Re: St. Lucie Plant Unit 1  
Docket No. 50-335  
Renewed Facility Operating License No. DPR-67

Response to NRC Reactor Systems Branch and Nuclear Performance Branch  
Request for Additional Information Regarding Extended Power Uprate License  
Amendment Request

**Response to  
NRC Reactor Systems Branch and  
Nuclear Performance and Code Branch  
Request for Additional Information  
Regarding Extended Power Uprate  
License Amendment Request**

### **Response to NRC Reactor Systems Branch and Nuclear Performance and Code Branch Request for Additional Information Regarding Extended Power Uprate License Amendment Request**

**Table 16-1: FSAR Chapter Figures and Comparative RLBLOCA Figure**

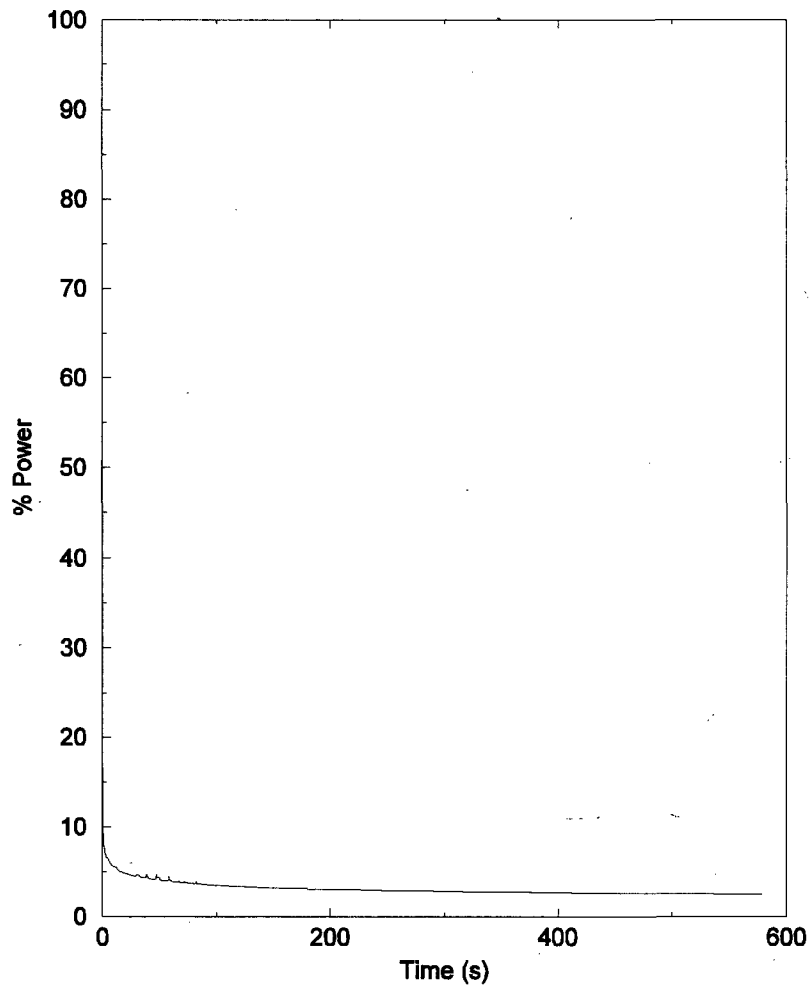
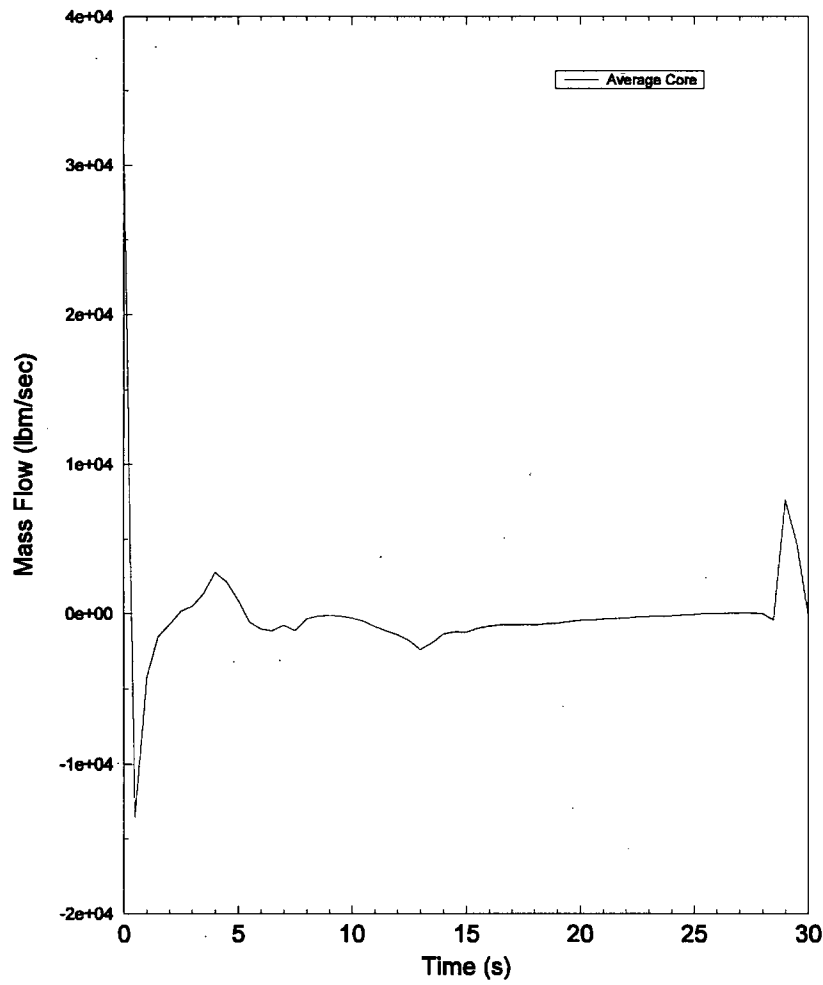
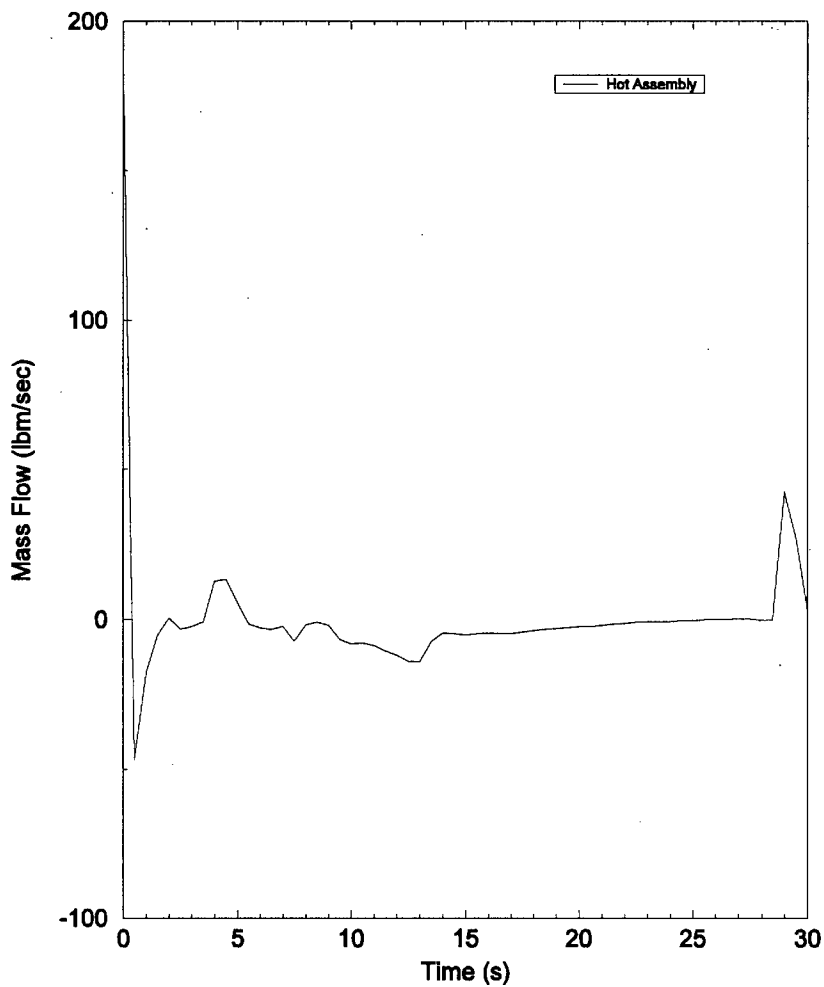
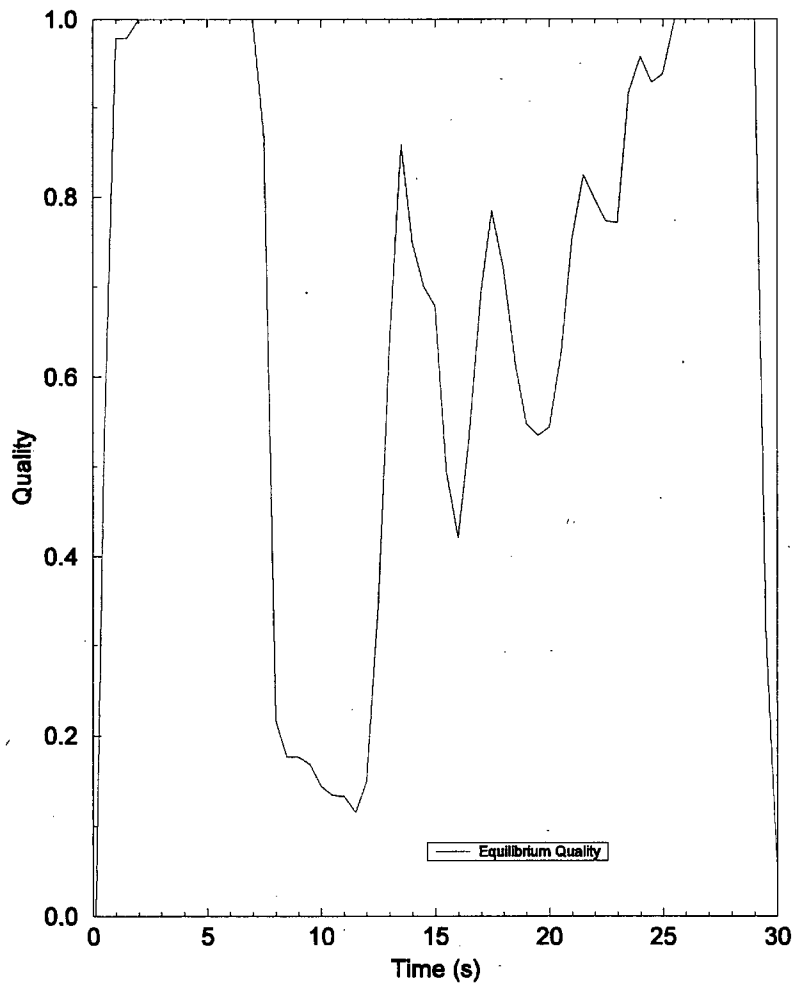
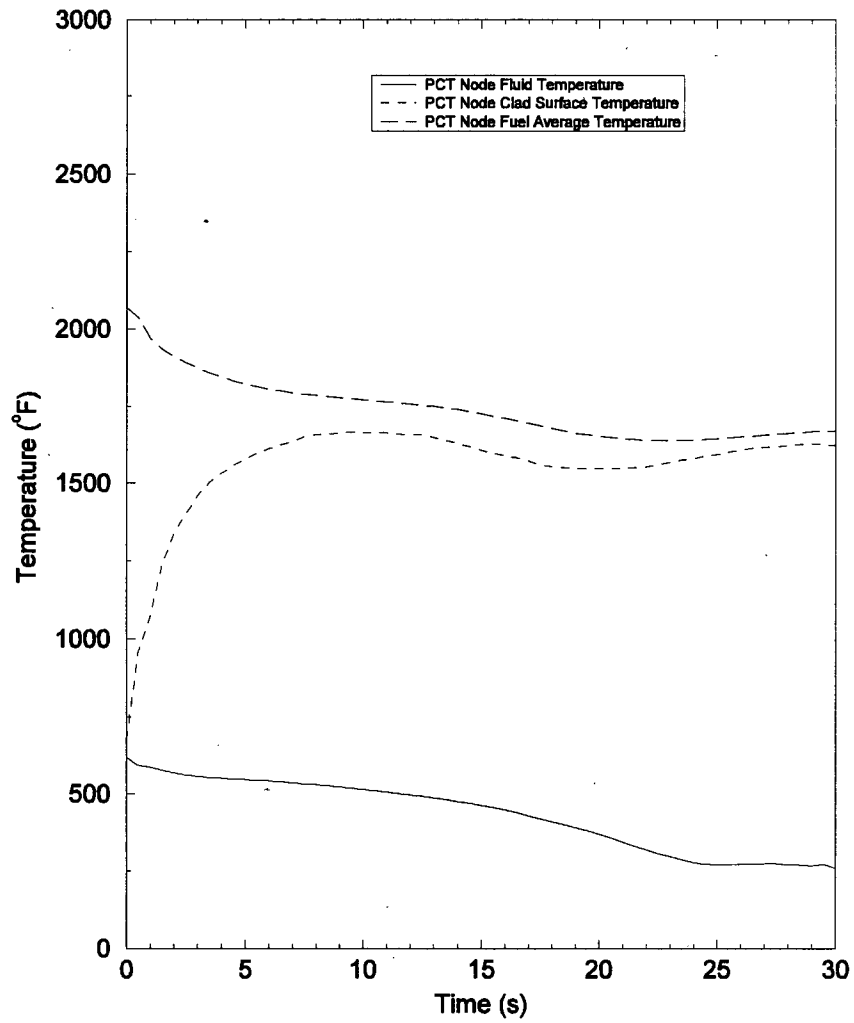
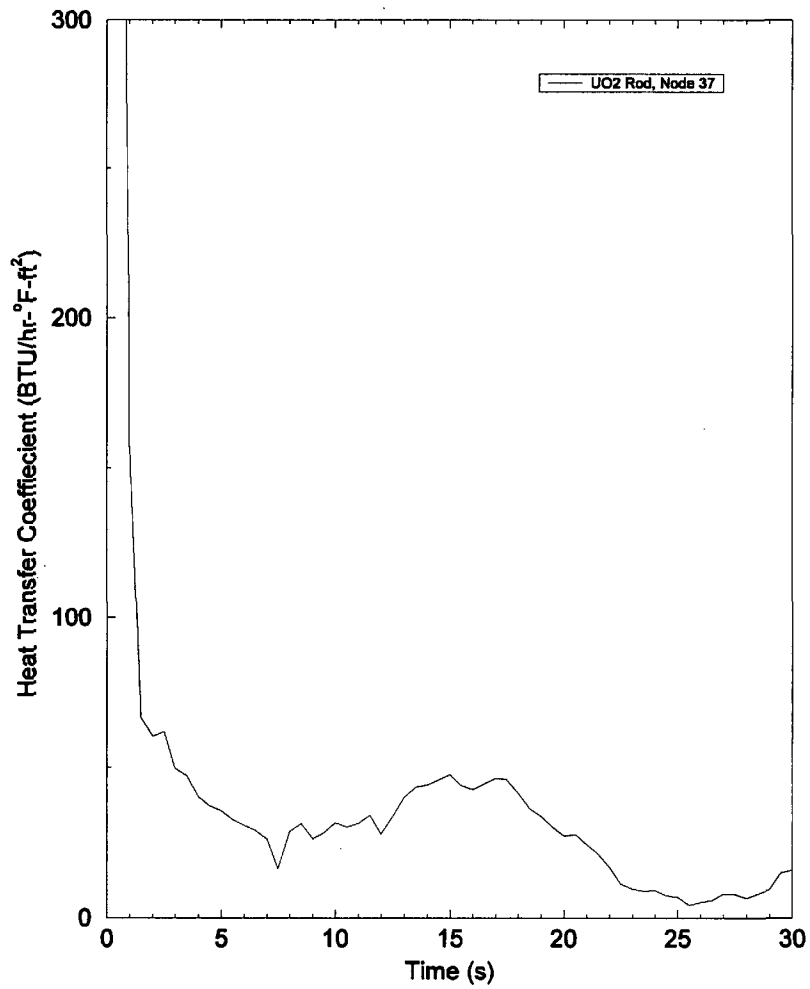
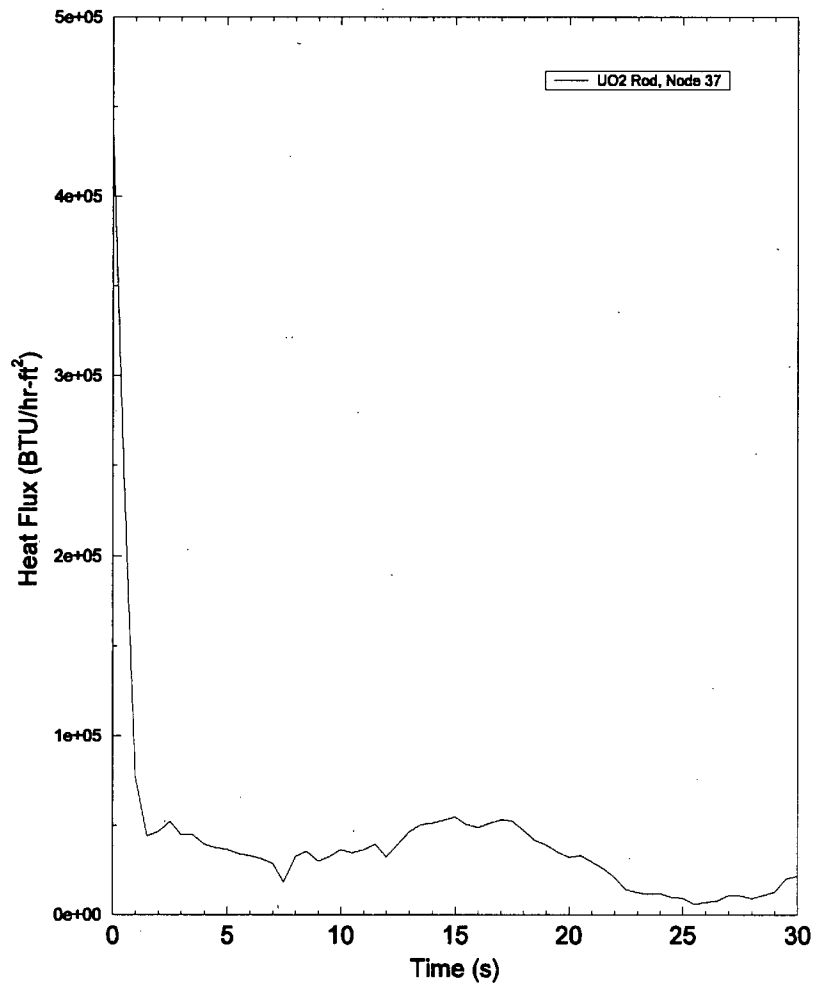
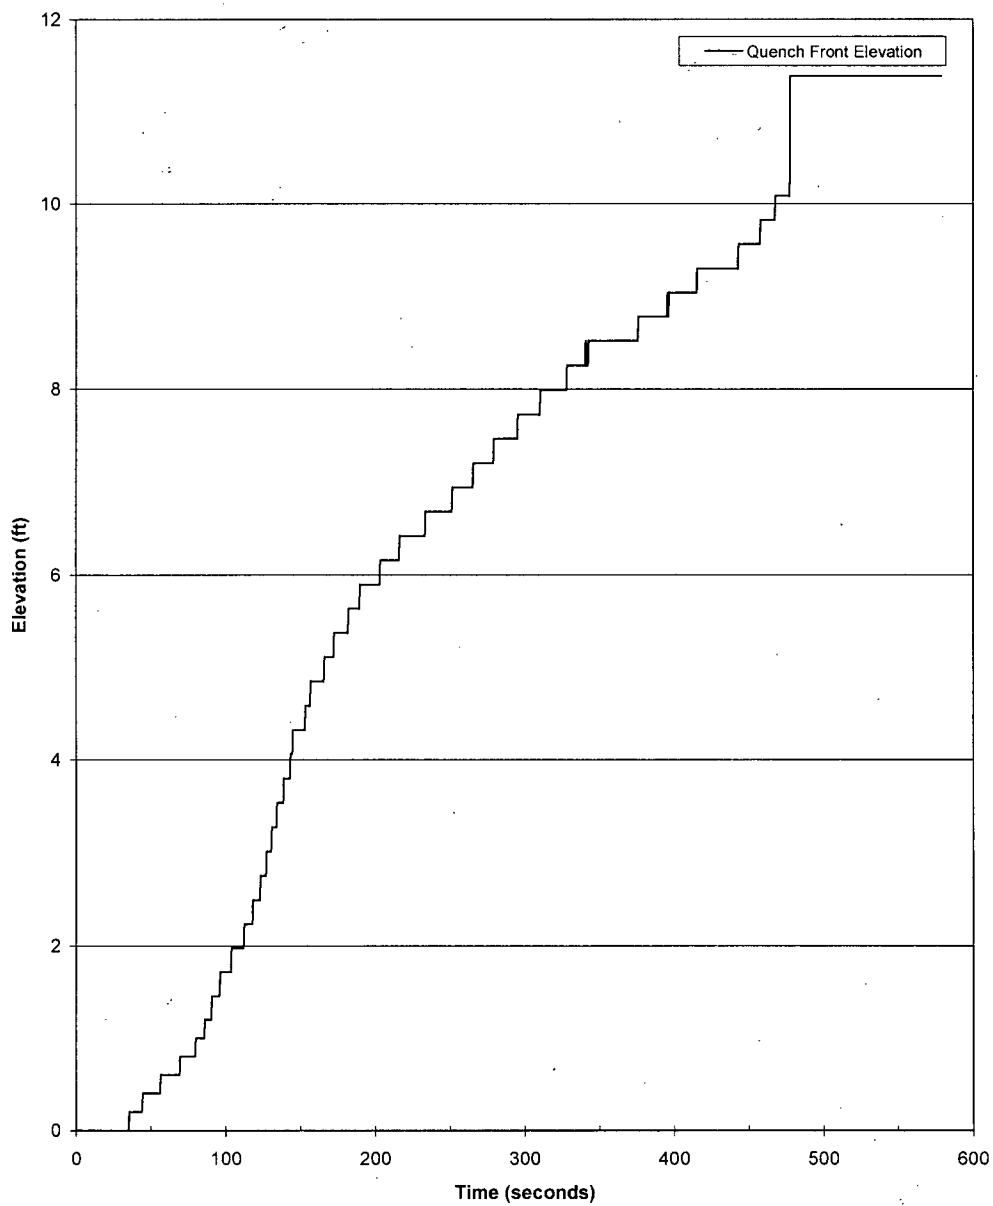
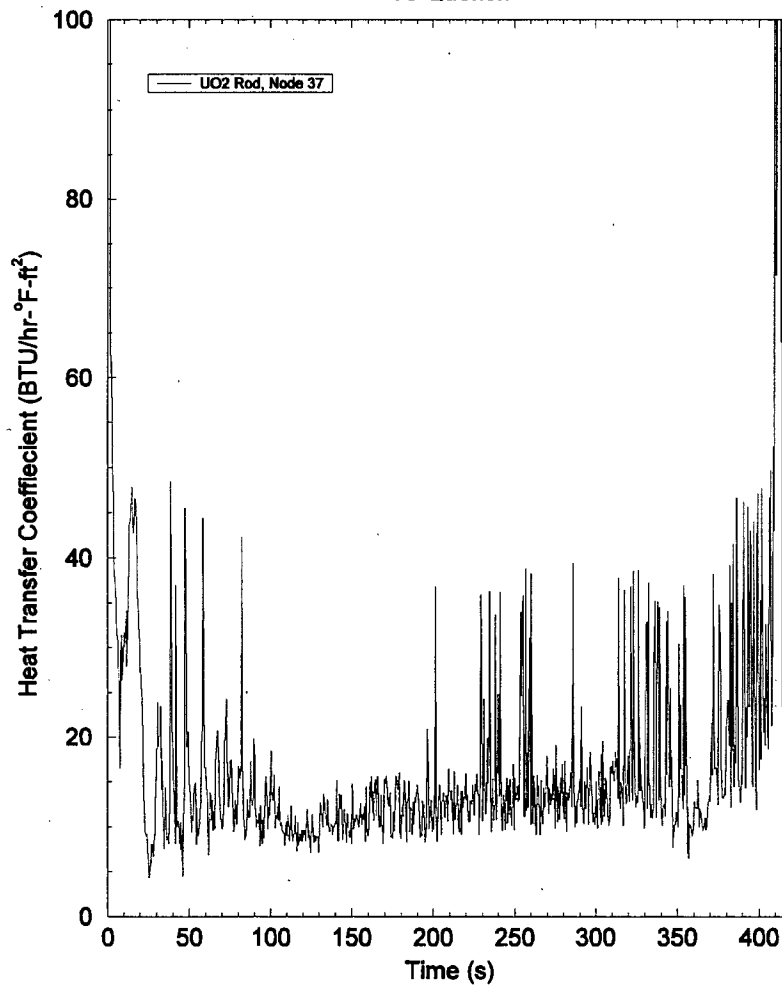
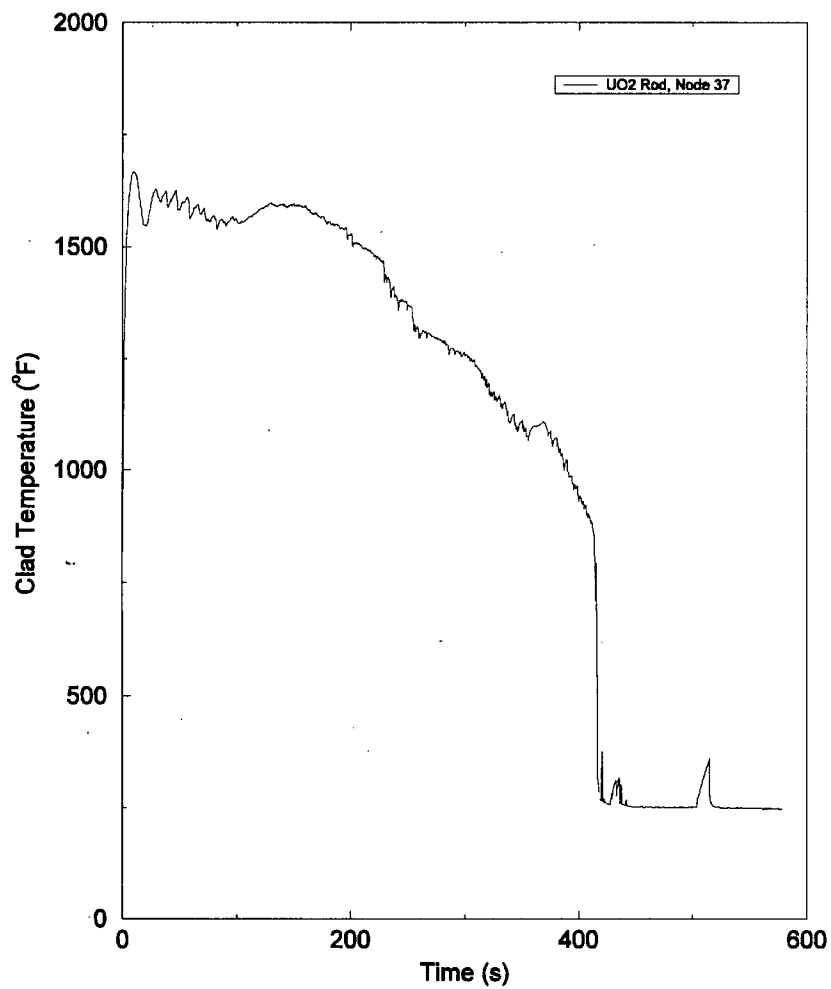
**Please provide the results of the seismic LOCA loads analysis for the limiting break. Identify the maximum hot channel deformation/flow area reduction, the maximum hot bundle flow area reduction, the peak linear heat rate for the hottest rod in the assembly undergoing maximum deformation. Also, provide the linear heat rate for the bundle containing the rod with the max deformation. The analysis should provide the plots typical of the limiting large break LOCA analysis given in a chapter 15 analysis.**

The LBLOCA figures in Section 15.4 of the St. Lucie Unit 1 UFSAR were reviewed and the following figures are provided to supplement those found in ANP-2903(P) Rev. 1 (Attachment 2 of Reference 1). Table 16-1 provides a list of the Chapter 15 FSAR figures and a cross-reference to where these figures are found in ANP-2903(P) Rev. 1 or in this RAI response.
